Category U	Technical	Ref. No. E033/05	Page 1 of 2
Coverage <input type="checkbox"/> Distributor only <input checked="" type="checkbox"/> Please inform your dealers		Date Issued December 20, 2005	
Please convey this information to your <input type="checkbox"/> Director <input checked="" type="checkbox"/> General Manager <input checked="" type="checkbox"/> Warranty Dept. <input checked="" type="checkbox"/> Parts Dept. <input checked="" type="checkbox"/> Training Dept. <input checked="" type="checkbox"/> Field Rep.		Date Revised	
Applicable Models RX-8 (FE / SE)		Applicable Countries or Specifications US & EC Spec.

Subject: Protector Set for A/C Condenser

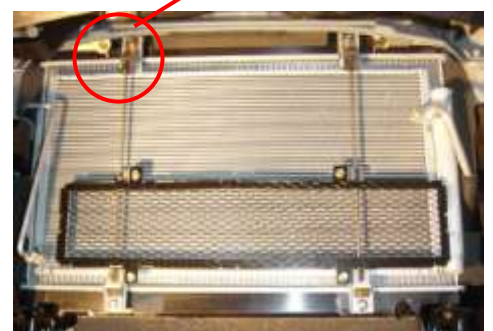
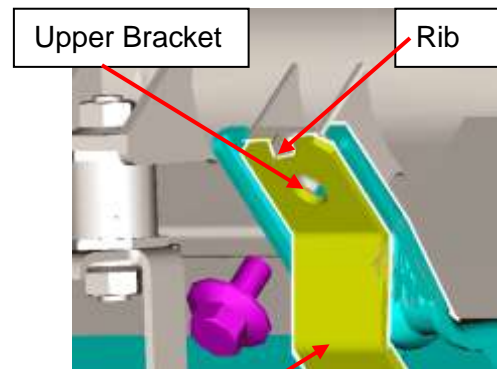
In order to protect the A/C condenser from damage caused by stones kicked up while driving, a protector set has been established.

1. Remove the under cover.
2. Remove the bolts from the A/C condenser.
3. Install a protector in the condenser of the radiator.
Note: Align the cut portion of the upper bracket and A/C condenser to the rib of the radiator, and then tighten the bolts.
4. Reinstall the under cover.
